Developer Services
Southern Water
Sparrowgrove House
Sparrowgrove
Otterbourne
Hampshire
SO21 2SW

Your Ref
EG/50/18/HH
Our Ref
PLAN-024159
Date
06/09/2018

Proposal: Demolition of double garage & erection of part one & two storey side extension.
Site: 2 Como, Barnham Road, Eastergate, PO20 3RT.
EG/50/18/HH

Southern Water MapGuide Browser

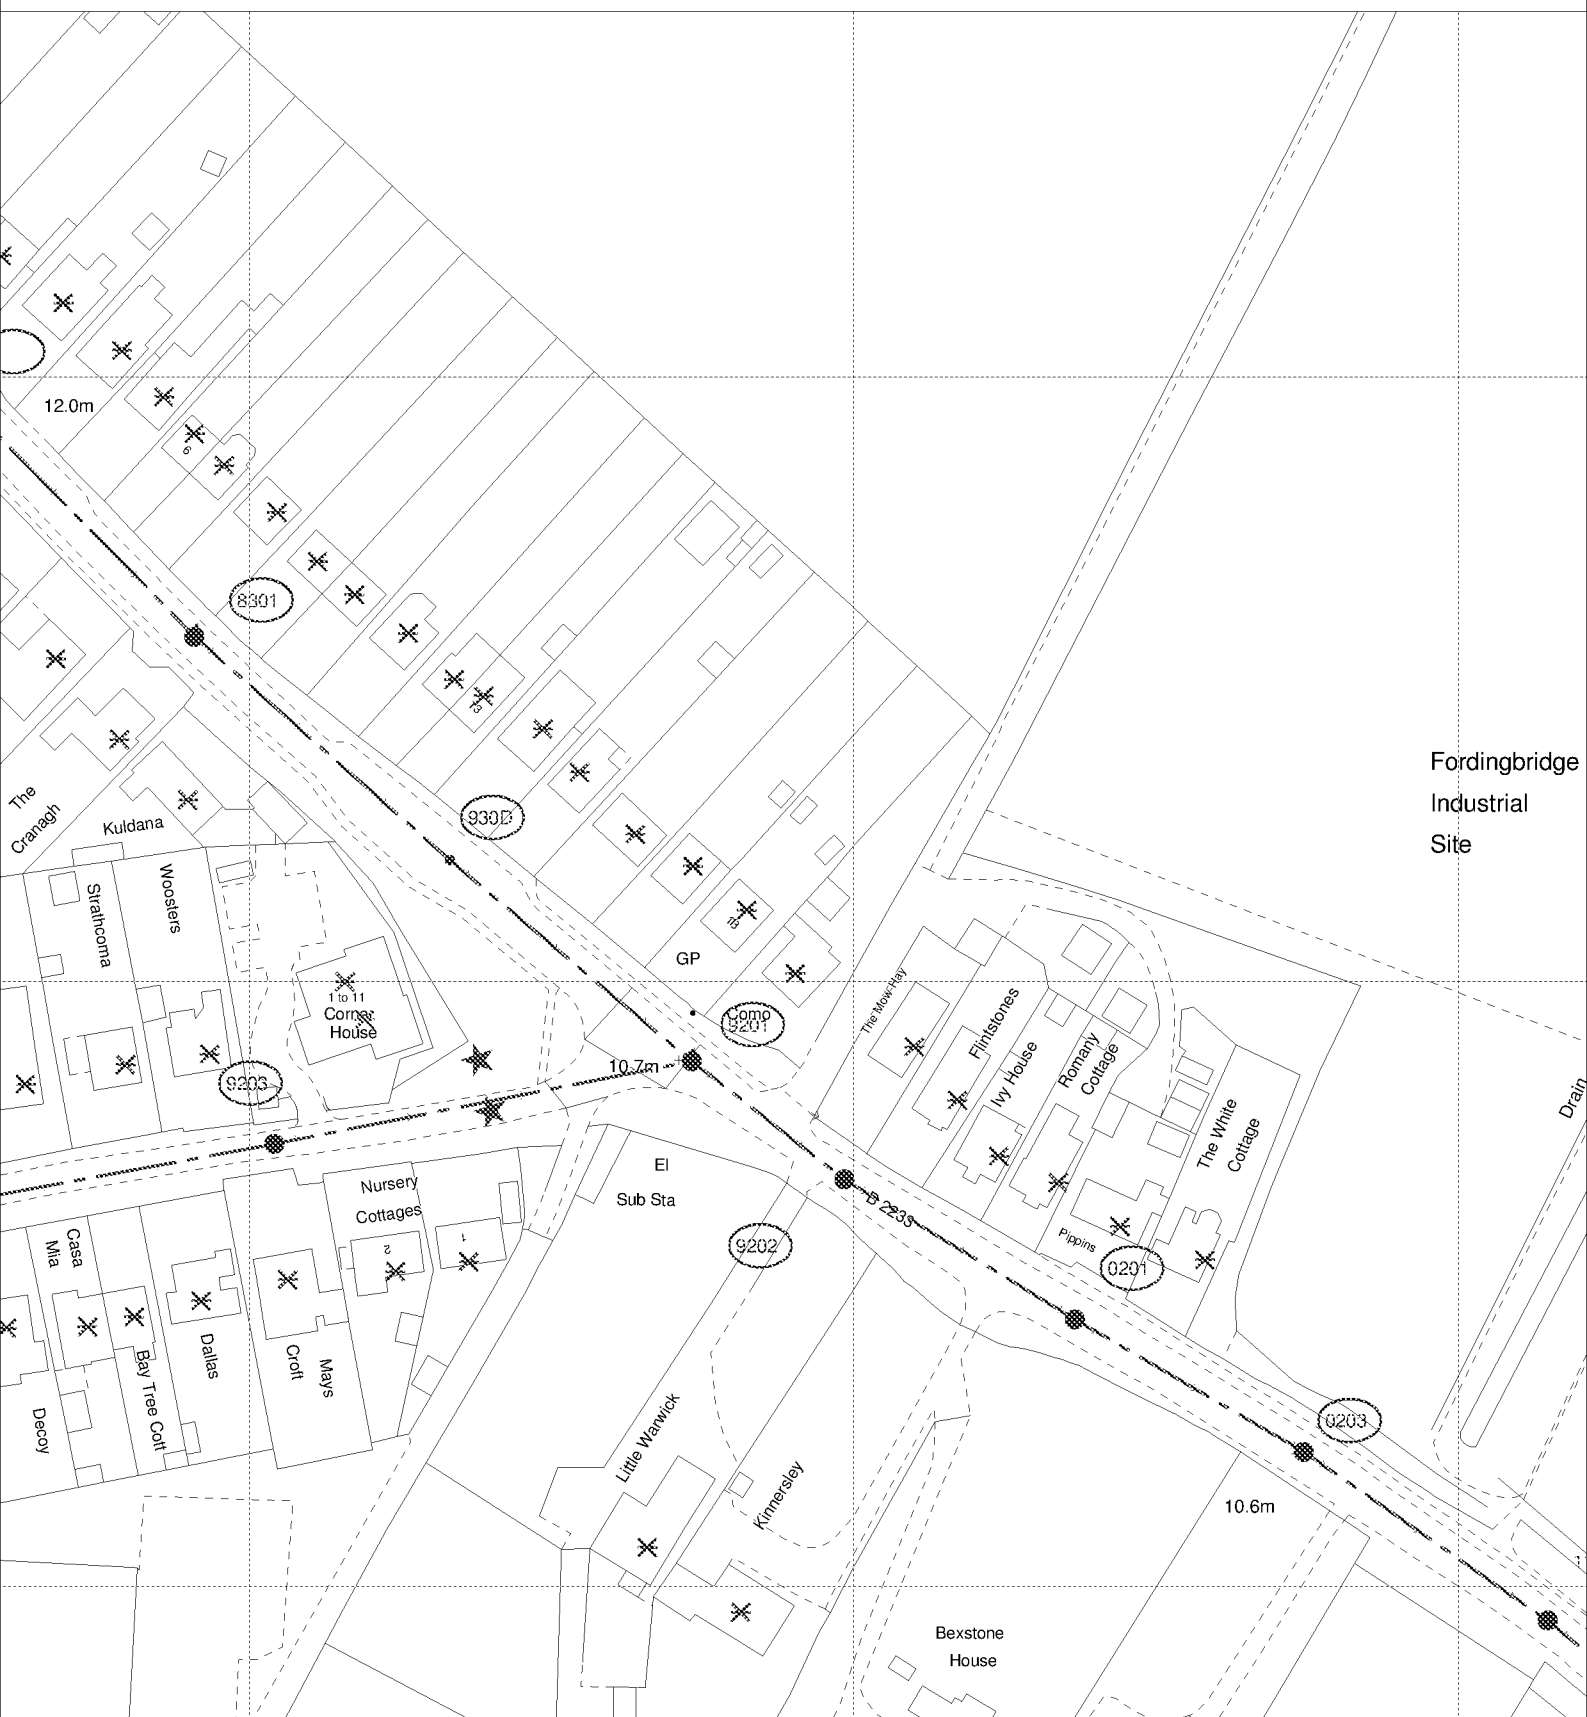
Due to changes in legislation that came in to force on 1st October 2011 regarding the future ownership of sewers it is possible that a sewer now deemed to be public could be crossing the above property. Therefore, should any sewer be found during construction works, an investigation of the sewer will be required to ascertain its condition, the number of properties served, and potential means of access before any further works commence on site.

Due to surface water inundation issues in the Lidsey Catchment "The applicant is advised to adopt, where appropriate, the measures in the table "Practical measures to reduce the potential impacts of development".

Developer should look to protect the public sewerage system from inundation and infiltration, which contribute to flooding in unfavourable conditions.
